Adjusting TDECQ Limit with Addition of 1T DFE

(Comments 159, 160, 161, 162, 163, 164, and 165)

**IEEE 802.3dj Interim Meeting
Minneapolis**

Sept 15, 2025

Supplier 1 - 200G SiPho MZM TDECQ with Addition of DFE

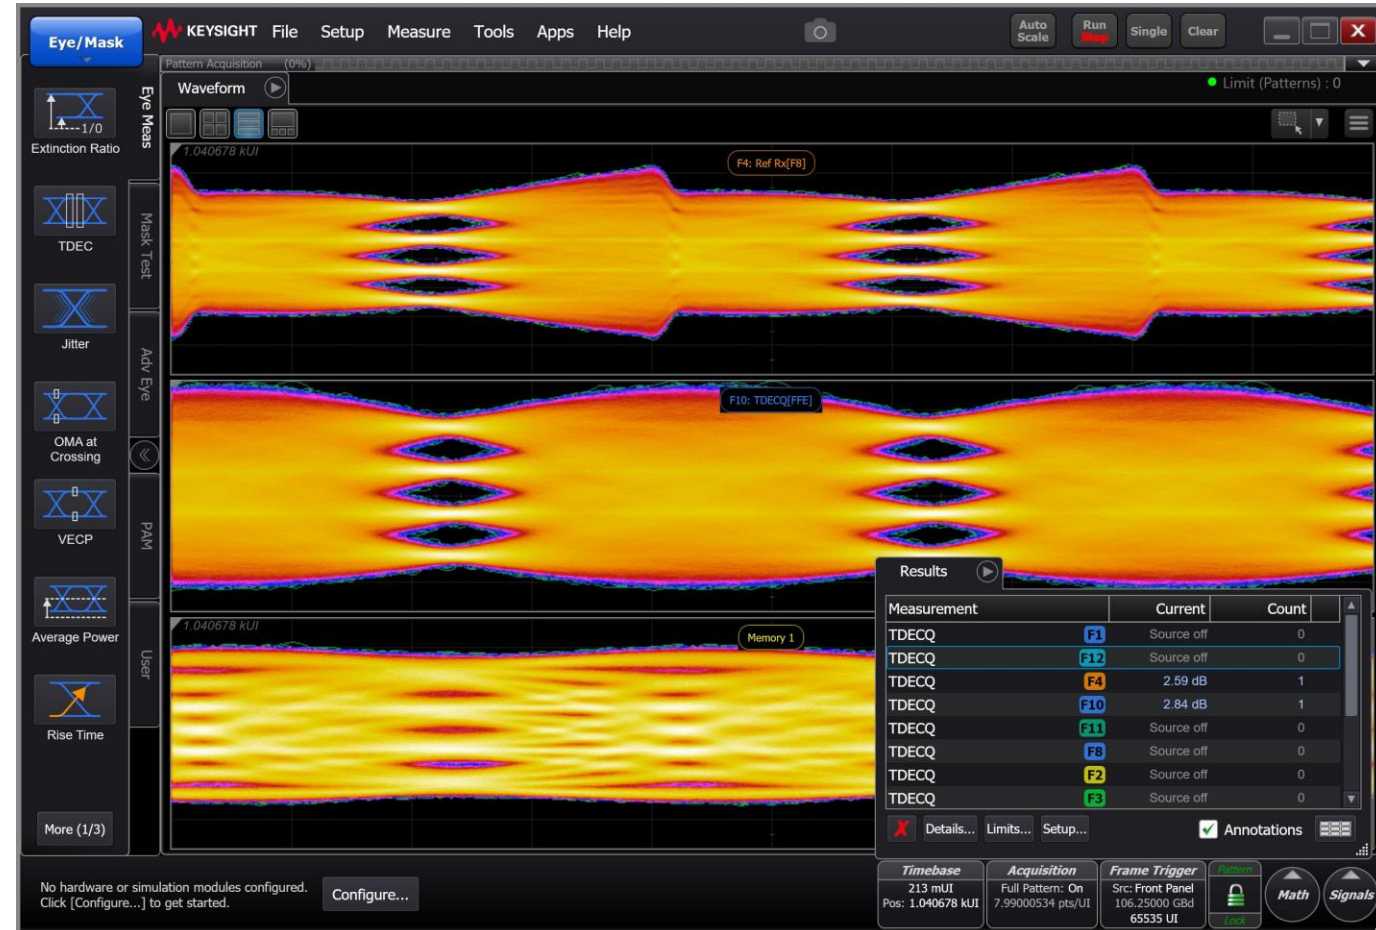
□ TDECQ reduction with 1T DFE for TX with low TECQ, see [ghiasi 3dj 04c 2507](#)

- TDECQ with 15T FFE is 2.84 dB
 - FFE Taps -0.017081, 0.078124, -0.275357, **1.490161**, -0.321593, 0.124306, -0.092210, 0.044500, -0.074899, 0.056275, -0.028502, 0.021386, -0.014024, 0.012652, -0.003738
- TDECQ with 15T FFE + 1T DFE is 2.59 dB
 - FFE Tap -0.008442, 0.045556, -0.166764, **0.995970**, 0.181786, -0.000968, -0.031856, 0.005959, -0.042369, 0.019865, -0.005469, 0.007087, -0.004892, 0.005041, -0.000504
 - DFE Tap 0.283636.

Supplier 1-200G Siphon MZM TDECQ with Addition of DFE

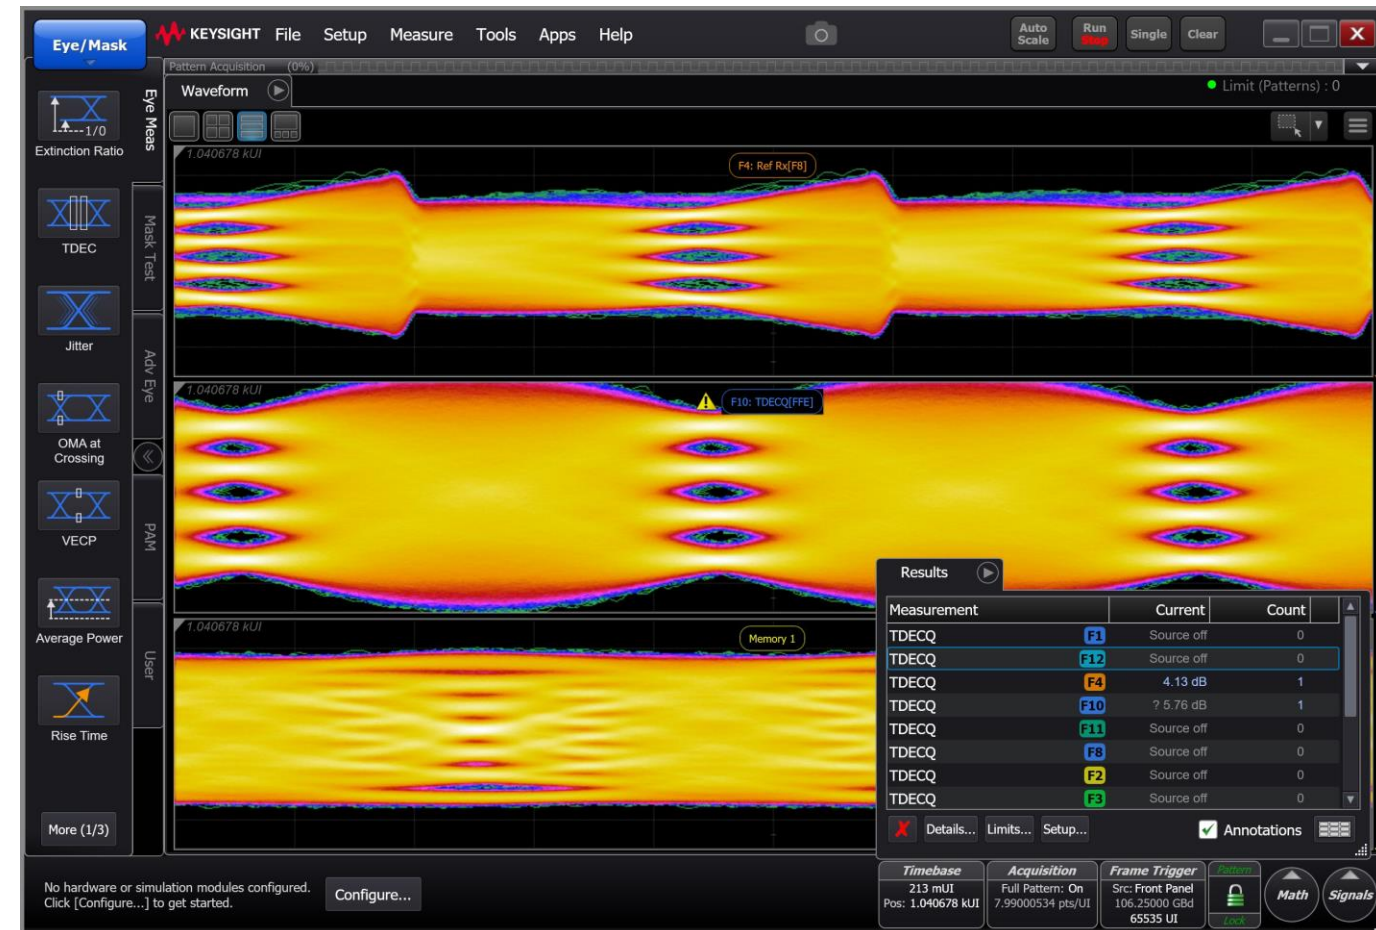
- TDECQ reduction with 1T DFE for TX with high TECQ, see [ghiasi 3dj 04c 2507](#)
 - TDECQ with 15T FFE is **5.76 dB**
 - FFE Taps -0.060232, 0.182759, -0.506969, **1.818684**, -0.532089, 0.157879, -0.044774, 0.005974, -0.044100, 0.035797, -0.010159, 0.003285, 0.018303, 0.004811, -0.029168
 - TDECQ with 15T FFE + 1T DFE is **4.13 dB**
 - FFE taps -0.017394, 0.073976, -0.226514, **0.979468**, 0.253183, -0.073706, 0.026715, -0.012512, -0.023035, 0.008908, 0.006088, -0.000323, 0.013989, 0.010717, -0.019560
 - DFE Tap 0.343287

Supplier 2-200G Siphon MZM TDECQ with Addition of DFE

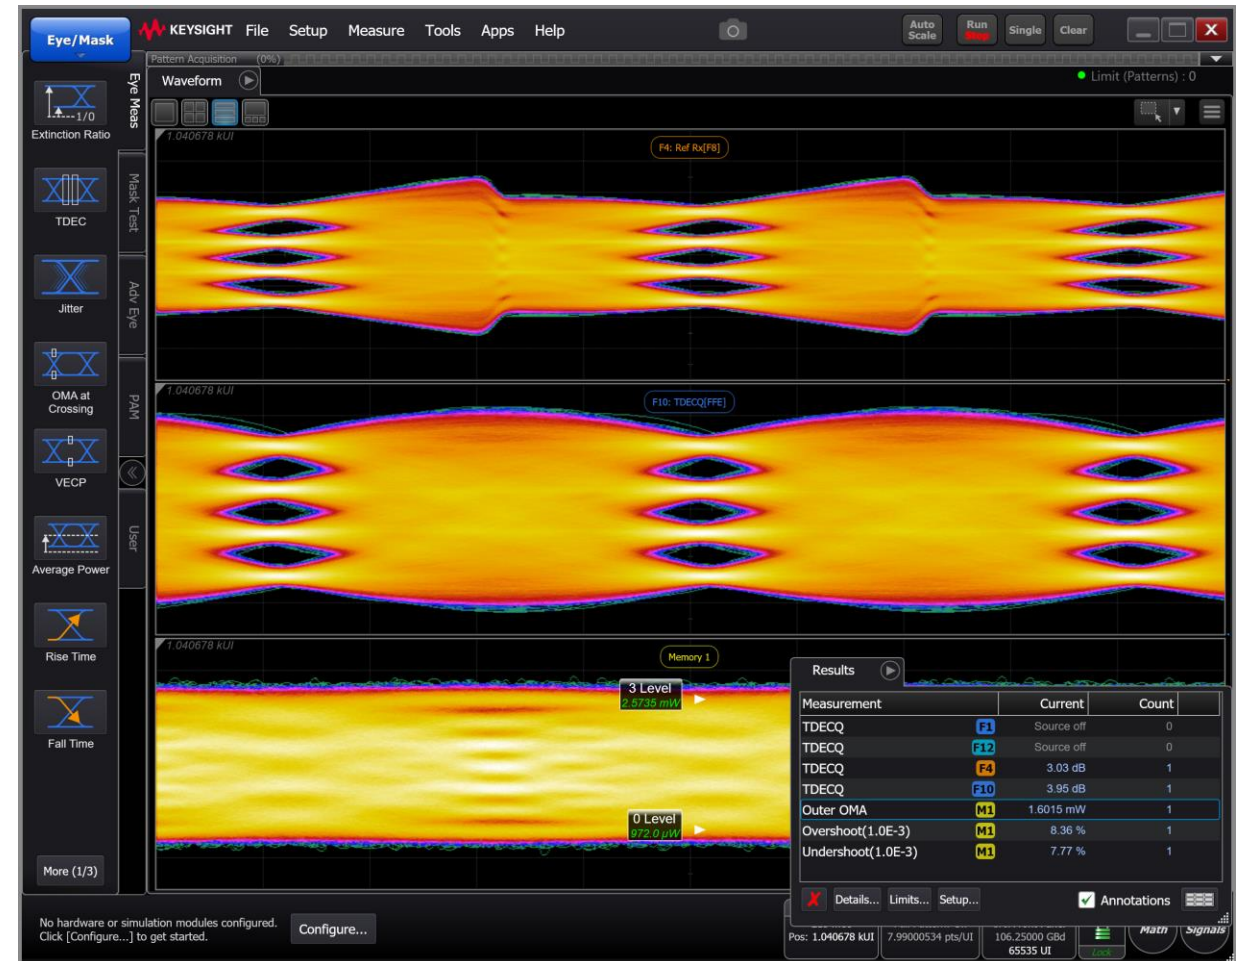
- TDECQ reduction with 1T DFE for TX with high TECQ
 - TDECQ with 15T FFE is **3.95 dB**
 - FFE Taps -0.026009, 0.080618, -0.264278, **1.465403**, -0.317154, 0.067630, -0.007742, -0.067456, 0.120564, -0.041145, -0.009050, 0.025035, -0.017886, -0.004995, -0.003535
 - TDECQ with 15T FFE + 1T DFE is **3.03 dB**
 - FFE taps -0.008907, 0.049752, -0.147116, **0.931613**, 0.141911, -0.024886, 0.015423, -0.041761, 0.069482, 0.007109, -0.011049, 0.019237, -0.000762, -0.003416, 0.003370
 - DFE Tap 0.243342

Supplier 3 EML TDECQ with Addition of DFE

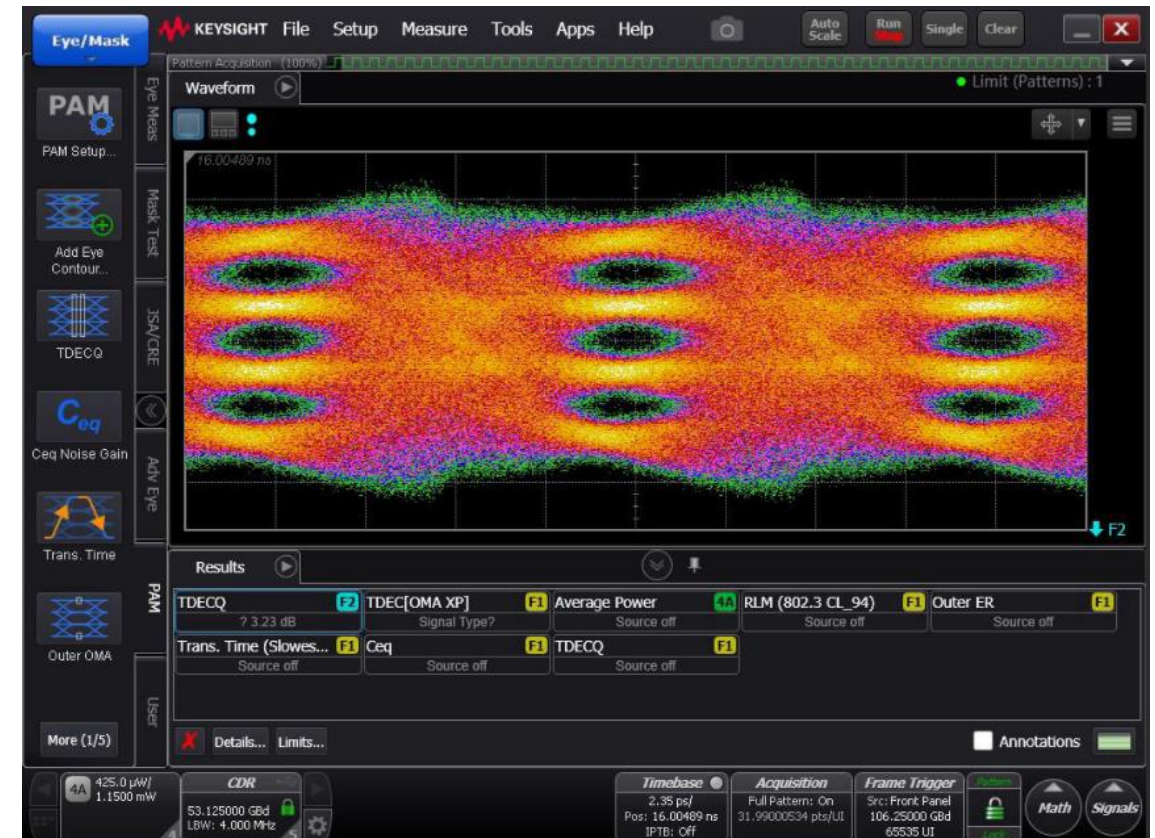
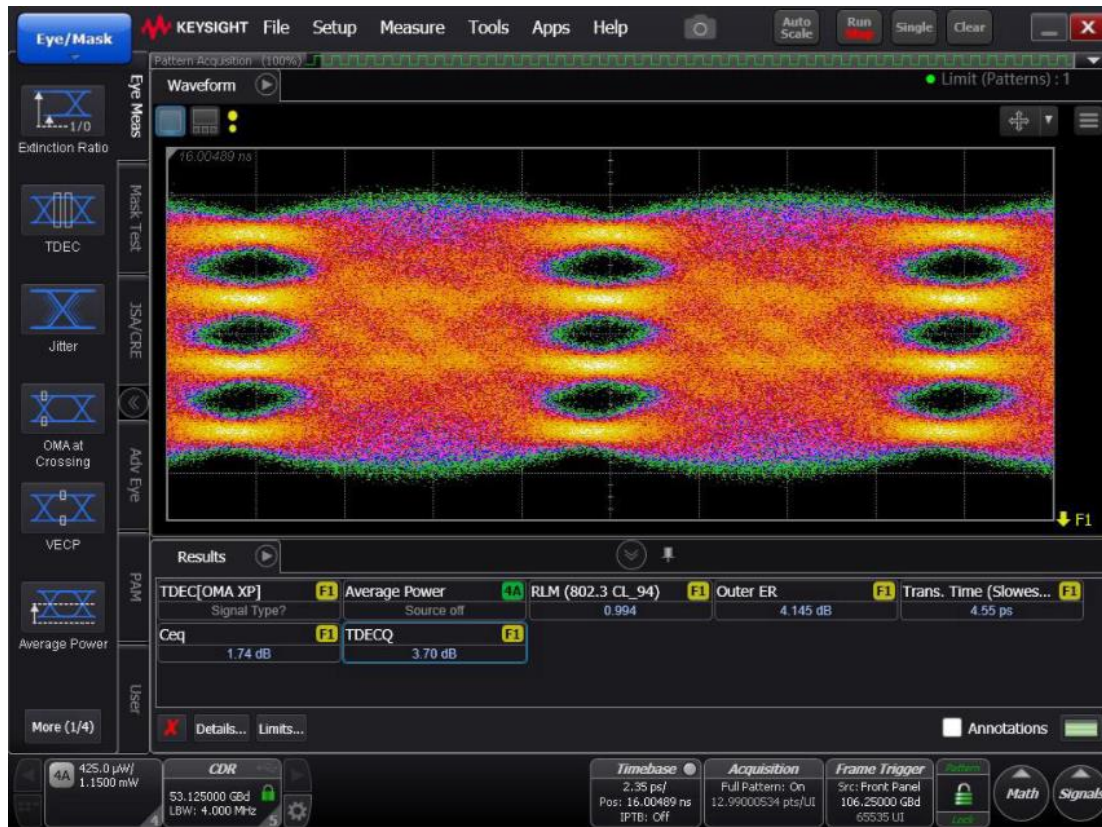
- ❑ Unfortunately, the data saved was after equalizer so can't report on exact equalizer settings or tap weights, but TDECQ did decrease by ~ 0.5 dB for this EML with DFE.

Benefit of Adding DFE to TDECQ

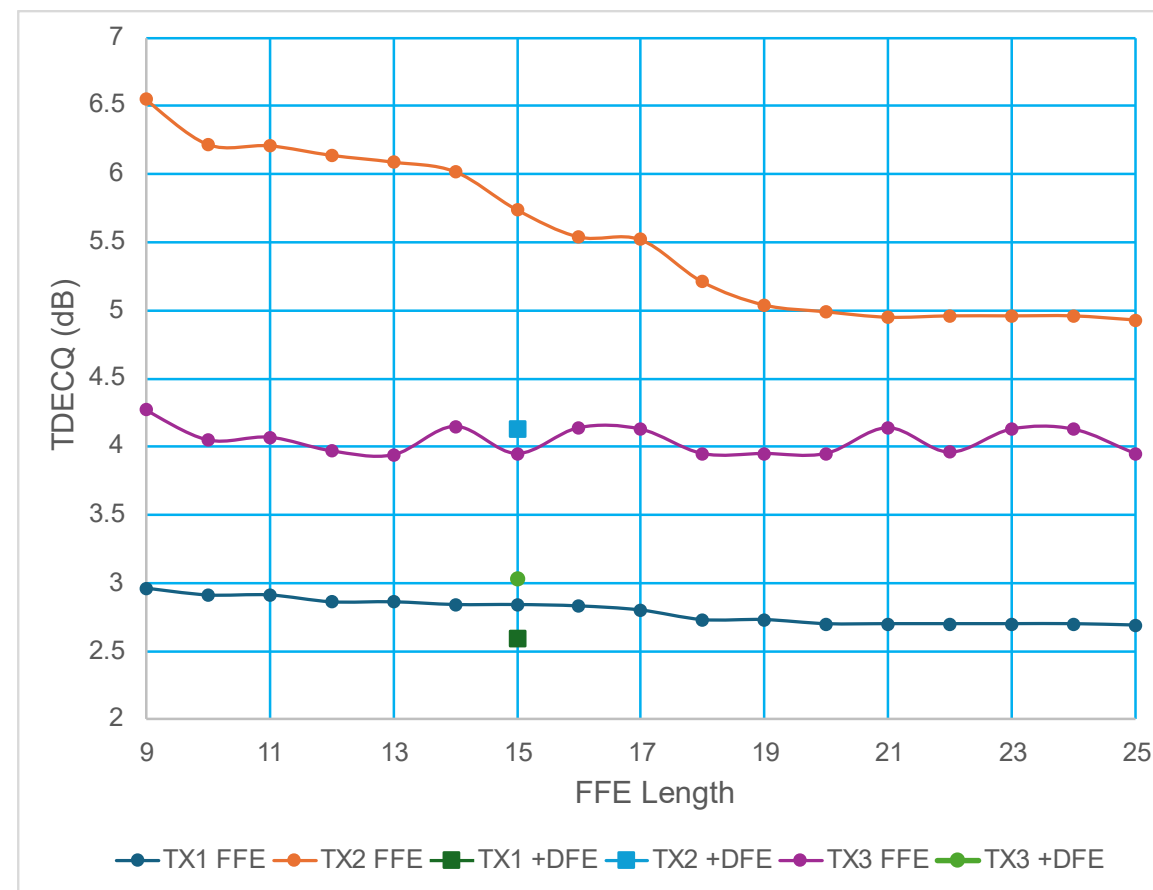
- ❑ Adding 1T DFE to current 15T FFE TDECQ offer more gain than even a 25T FFE
- ❑ Adding 1T DFE also improves TDECQ to Receiver sensitivity penalty
- ❑ TECQ reduction with the addition of 1T DFE
 - Only ~ 0.25 dB low TECQ TX1 transmitter
 - ~ 1.5 dB for high TECQ ISI impaired TX2 transmitter
 - ~ 1 dB low noise dominated TX3 transmitter
 - EML raw data was not available to include
- ❑ DFE is providing gain across a range of transmitters!

Supplier 1 and 2 TDECQ Results with/without DFE

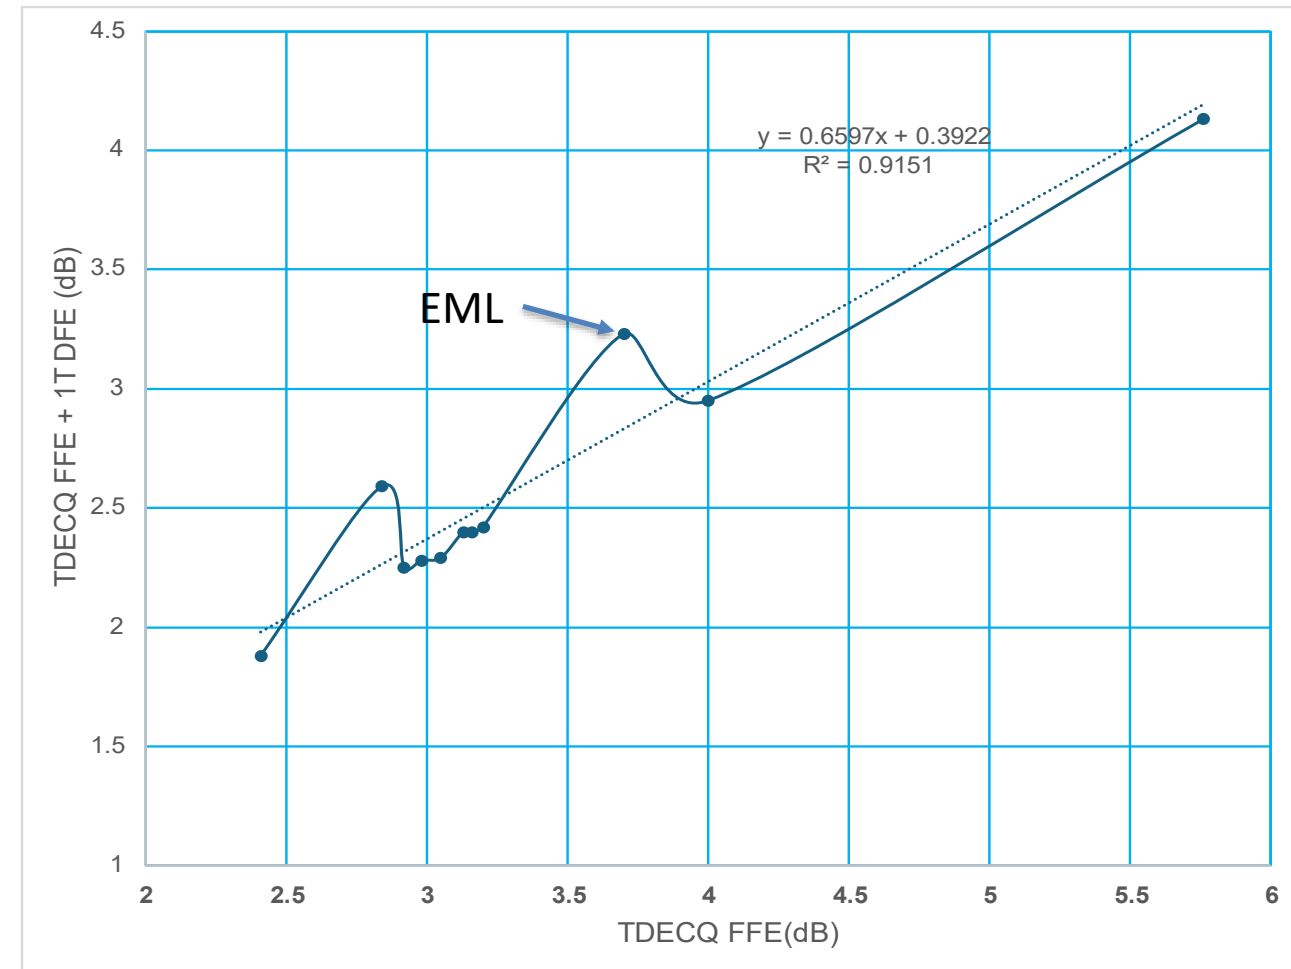
- ❑ The 3.4 dB FFE TDECQ limit is equivalent to 2.6 dB TDECQ limit with DFE
- ❑ A 3.4 dB DFE TDECQ limit is equivalent to an FFE TDECQ of 4.7 dB which is your typical Functional Receiver
- ❑ Propose to reduce TDECQ for inner FEC PMDs given relaxation from DFE and higher SER!

Excessive Overshoot/Undershoot can Result in FEC Tail

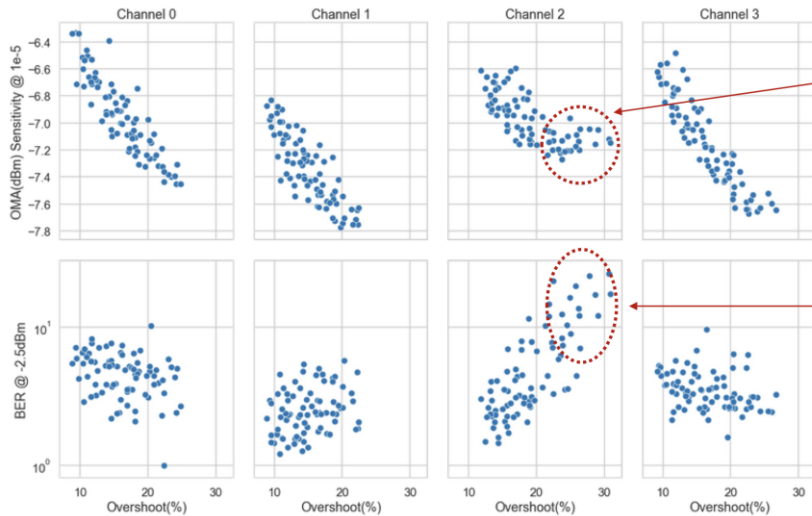
❑ Currently TDECQ doesn't incorporate PAR (Peak to Average) penalty

- Without PAR penalty overshoot can drive the TDECQ lower while link BER degrades
- TDECQ not having PAR penalty the overshoot should be reduced <12% as receiver with DFE don't require such large overshoot!

Overshoot vs Rx performance

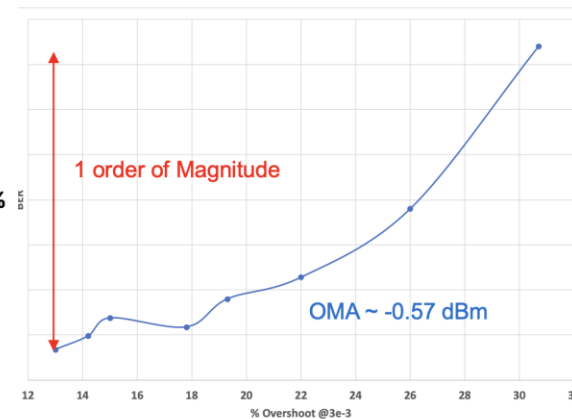
❑ Overshoot tends to improve sensitivity. It saturates for values larger than 22%

❑ Overshoot values larger than 22% increase error floor significantly

Overshoot vs Ceq Protecting Receiver for Excess Overshoot

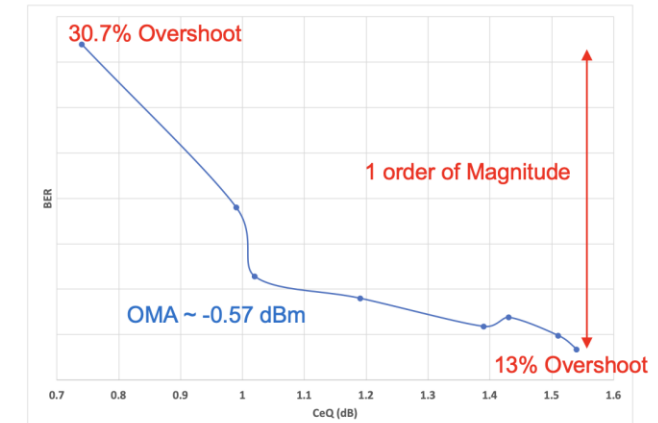
- Transmitter overshoot is a direct quantitative parameter protecting the receiver for excess pre-emphasis/overshoot
